<b>SERVICE</b> 		<b>3</b>
		<b>B9901027</b>

## SB, 55 Rancher, 55, 51, Ignition module, 1999-09

503 90 14-01

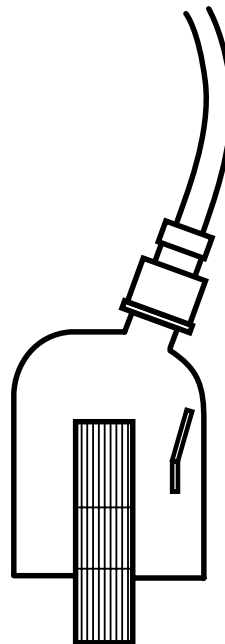
A new ignition module has been introduced on the above models. The new ignition module is fully interchangeable with the earlier variant.

New ref. no.	Description	Excl. ref. no.	Remarks
503 90 14-01	Ignition module	503 90 12-01

Introduced into production from serial number:	55 Rancher	91102001
	55	91300901
	51	91200701
